Manual Supplement

Manual Title:	2640A/2645A NetDAQ Service	Supplement Issue:	3
Part Number:	942615	Issue Date:	8/05
Print Date:	March 1995	Page Count:	7
Revision/Date:

Figure A.

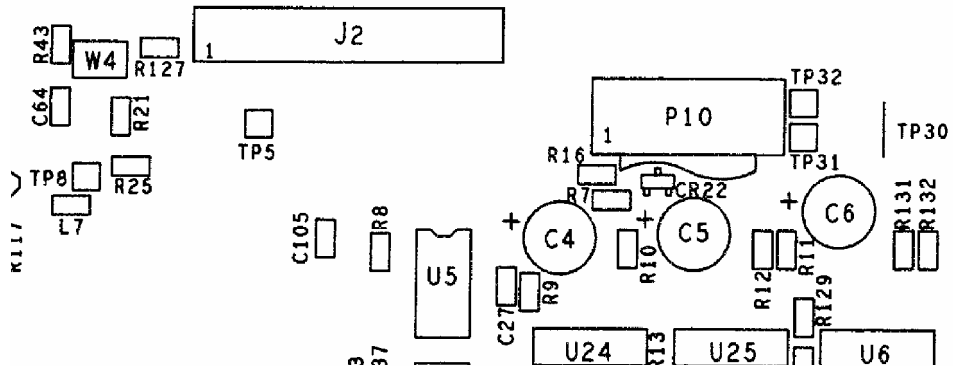
On pages 6-14 and 7-3, Figures 6-2 and 7-1, add C105 as shown in Figure A.

Figure B.

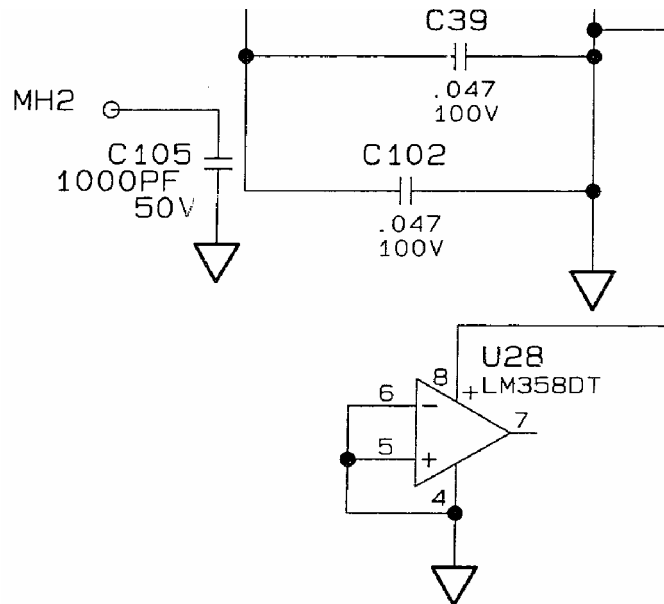
On page 7-4, Figure 7-1, add C105 as shown in Figure B.

Figure 4-1. Performance Test Setup

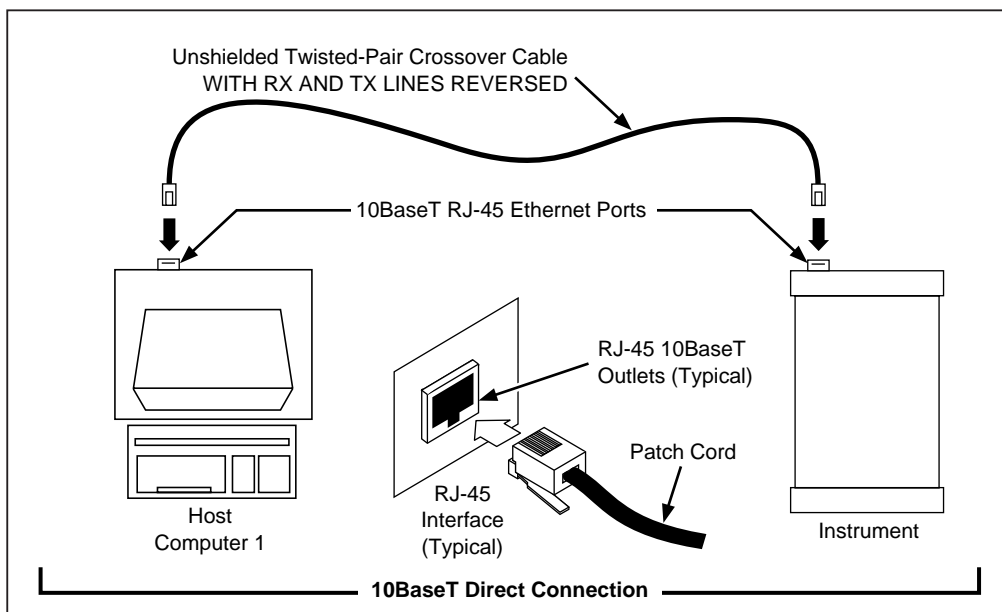
1. **Connect the Instrument and Host Computer** Make the network connections to the instrument and the host computer using a suitable RJ45 UTP Crossover cable as shown in Figure 4-1.

On page 4-5, replace Figure 4-1 with the following:

Figure C

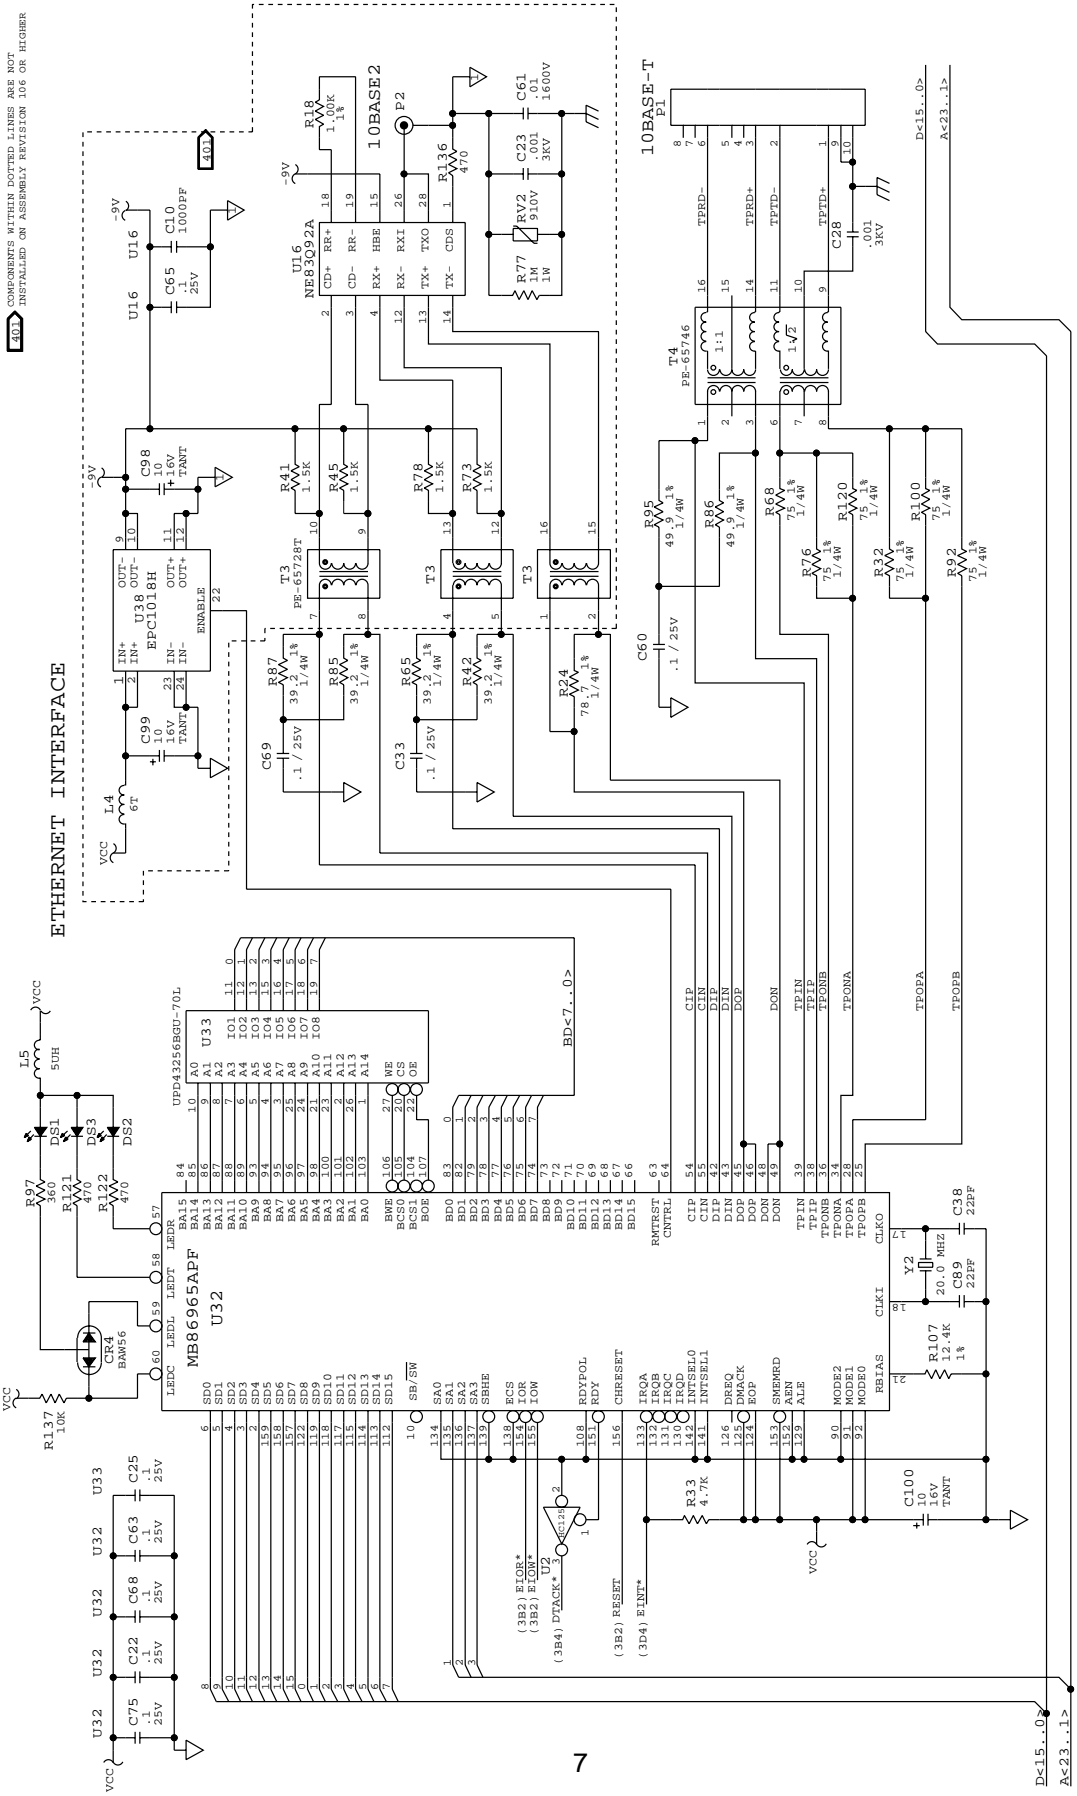
On page 7-6, Figure 7-1, replace sheet 4 of the schematic with Figure C.

COMPONENTS WITHIN DOTTED LINES ARE NOT INSTALLED ON ASSEMBLY REVISION 106 OR HIGHER
